Classification: A
Billable to Telco: Yes X No

APPARATUS AFFECTED: All 28 and 35 Automatic Send-Receive (ASR) Sets.
All 28 and 35 Perforator Transmitter Bases (LAK).
All 28 Transmitter Distributor Bases (LCXB).
All Model 28 Typing Perforator Units (LTPE).
All Model 28 Non-typing Perforator Units (LPE).

REASON FOR REISSUE: To allow for manufacturing variables, by providing a longer mounting screw.

REASON: To prevent accidental insertion of foreign objects into gears and couplings.

ADDING GUARDS FOR MODEL 28 ASR SETS

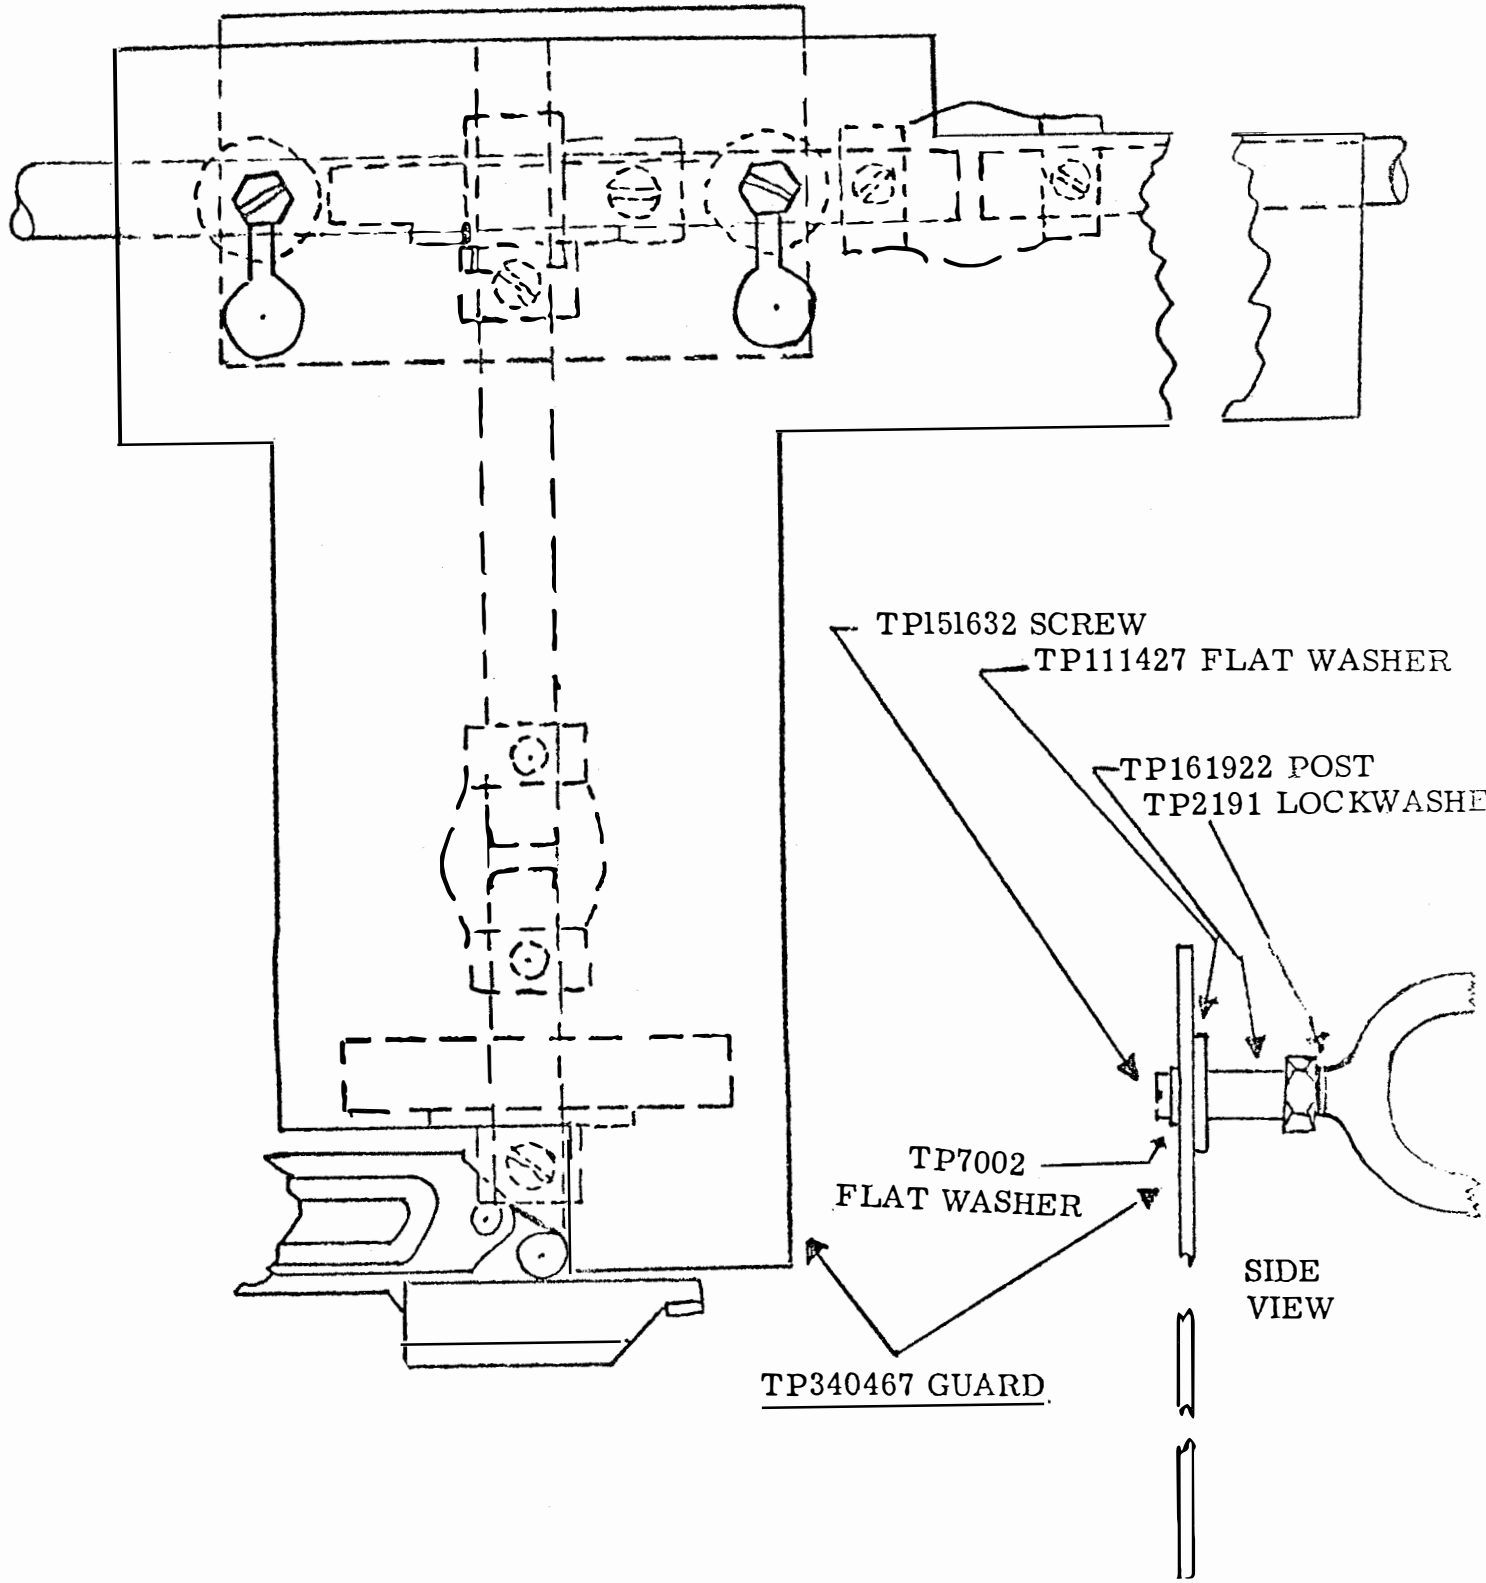
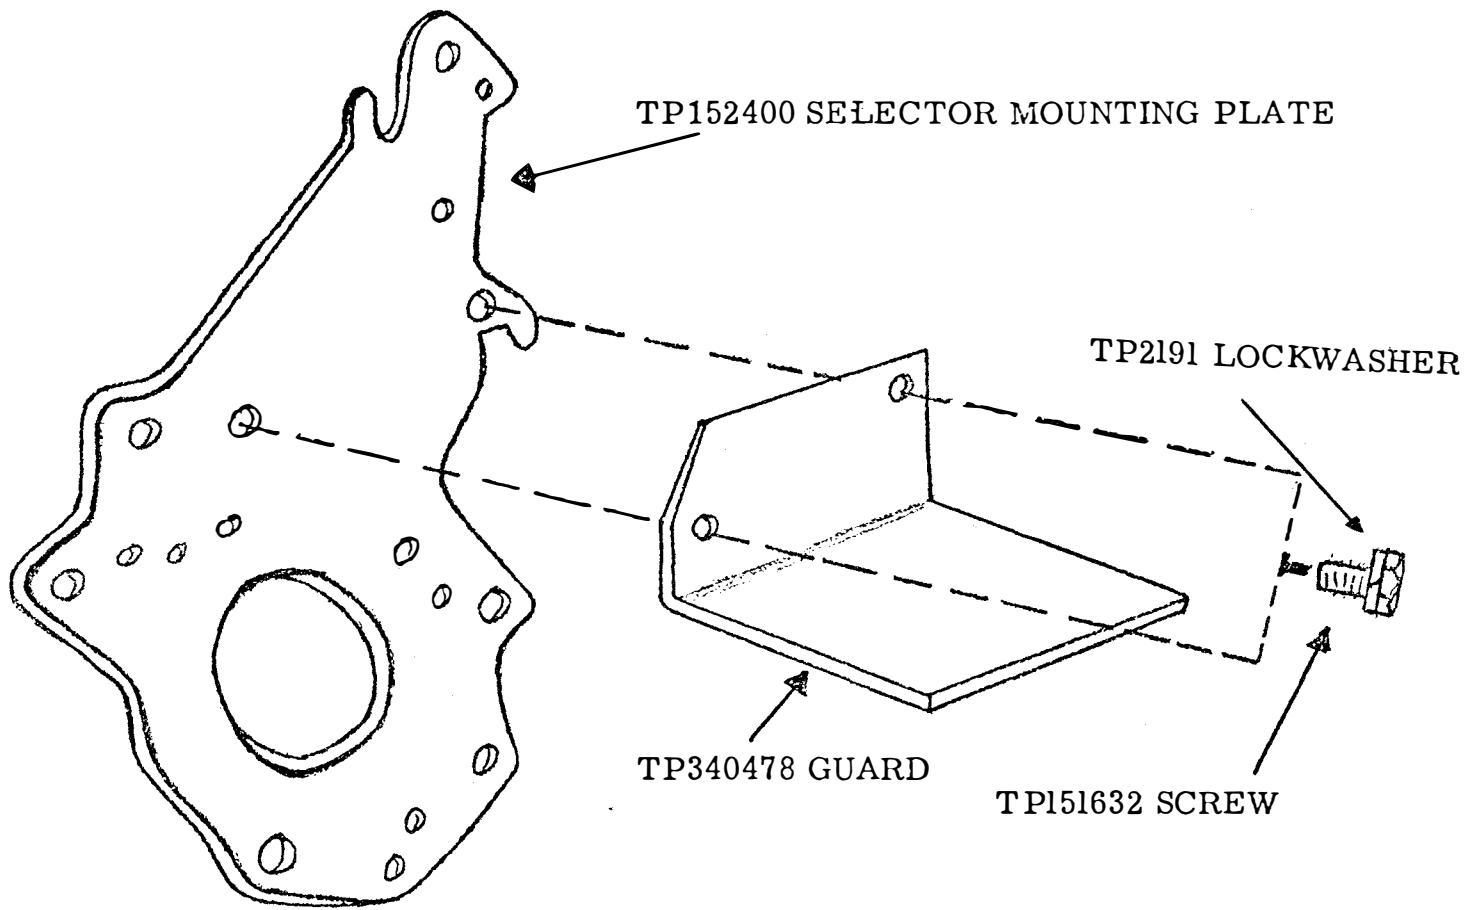
1. On all Model 28 ASR sets without an auxiliary reperforator, remove the TP158271 gear guard, (2) TP151631 screws, (2) TP2191 lockwashers and (2) TP7002 flat washers from the rear of the transmitter base (LCXB). Retain the (2) TP2191 lockwashers and (2) TP7002 flat washers. Discard all the other parts. Install, using the same mounting holes, (1) TP340468 gear guard, (2) TP151632 screws and (2) TP111427 flatwashers (see Attachment Sheet 3). If the set contains an auxiliary reperforator, discard the TP340468 gear guard and hardware.

2. On all Model 28 ASR sets remove the TP158271 gear guard, (2) TP151632 screws, (2) TP2191 lockwashers and (2) TP7002 flat washers from the bearing bracket assembly at the rear of the keyboard base (LAK). Retain the (2) TP2191 lockwashers and (2) 7002 flat washers. Discard all other parts. Install using the same mounting hole (2) TP161922 posts, (2) TP2191 lockwashers, (2) TP111427 flat washers, (1) TP340467 gear guard and (2) TP151632 screws. The perforated tab on the gear guard may be bent up or broken off if necessary (see Attachment Sheet 4).

3. On all Model 28 ASR Sets that contain a typing perforator (LPE) or non-typing perforator (LTPE), install the TP340478 eccentric guard on the right side of the LPE or LTPE above the power back-space eccentric using the (2) TP151632 screws and (2) TP2191 lockwashers see Attachment Sheet 5). If the set contains an LPR instead of an LTPE, discard the eccentric guard and mounting screws.

TP340468 GUARD

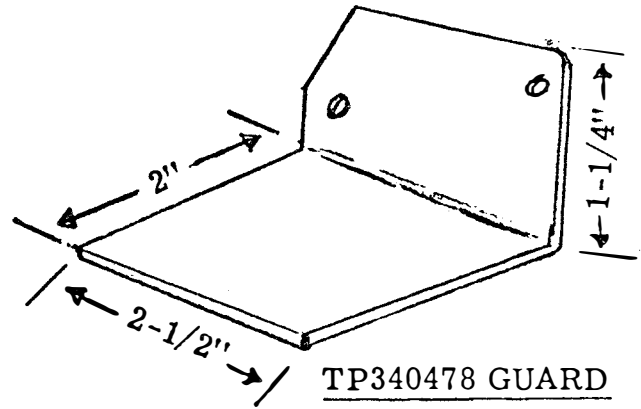
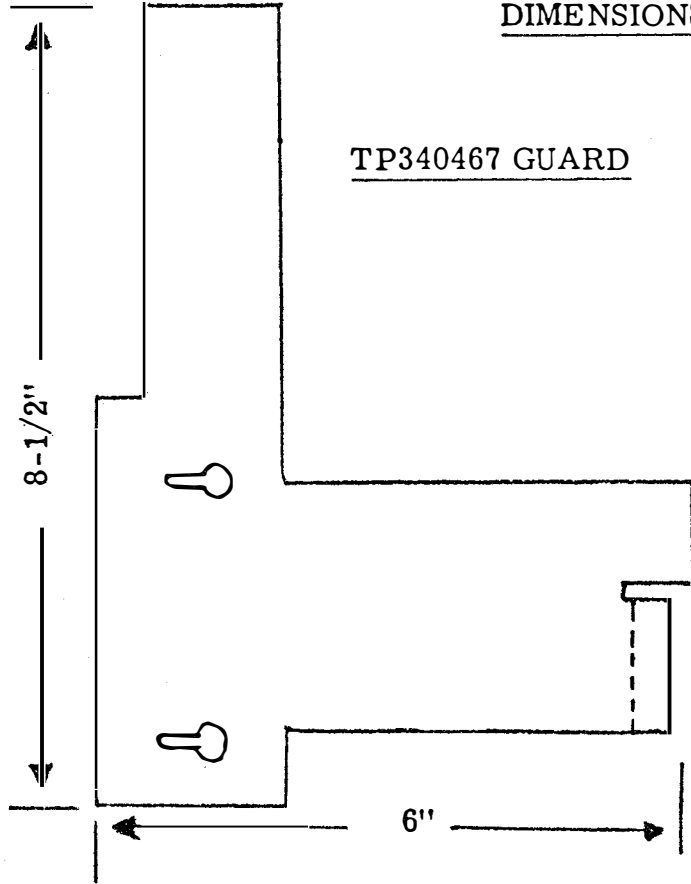
CHANGE: (1) On all 28 transmitter distributor bases (LCXB), the TP158271 gear guard (1), TP151631 screw (2), and TP125015 flat washer (2), are removed and replaced by a TP340468 gear guard (1), TP151632 screw (2) and TP111427 flat washer (2). See Attachment Sheets 3 and 6.
